EAST HADLEY ROAD
No House #

**APPLICATION FOR PERMIT TO CONSTRUCT OR REPAIR
A PRIVATE SEWAGE DISPOSAL SYSTEM**

No. 12-59

PERMIT TO CONSTRUCT OR REPAIR A PRIVATE SEWAGE DISPOSAL SYSTEM

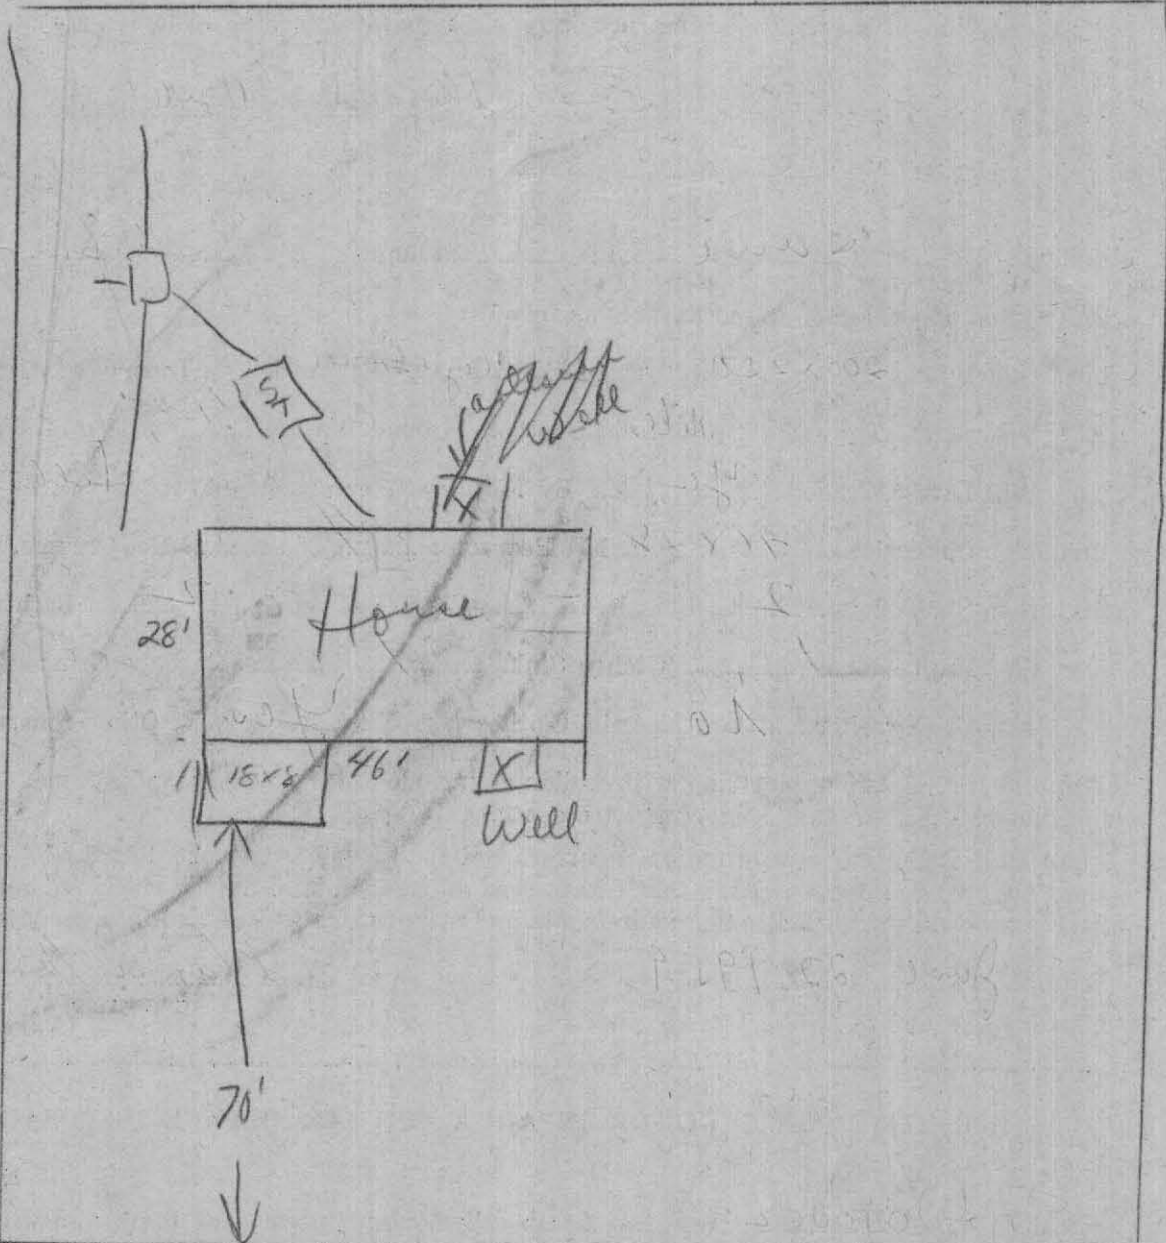
A check of the soil conditions on the property you are building on - East Hadley Road shows solid compact clay of the poorest qualities.

This is to inform you that because of this condition you will be required to use only a system of leaching tile over a bed of bank run gravel - a minimum area of 600 sq. ft. (six hundred) no less than 18" in depth. Over this bed there will be no less than two (2) leaching lines over 6" or more washed or screened gravel stone and further covered to a depth of 2" or more with stone (1/8" - 1/4" Size). All this leading from a distribution box with places for extra leaching lines for possible future use.

Septic Tank: Must be of Cement and of 1750 Gals. Liquid Capacity. No Dry Well
Leaching System: Trenches of not less than 300 Sq. Ft. bottom area. OR Dry Well
Dry well ft. bottom area and ft. below the inlet.
Other

See attached letter
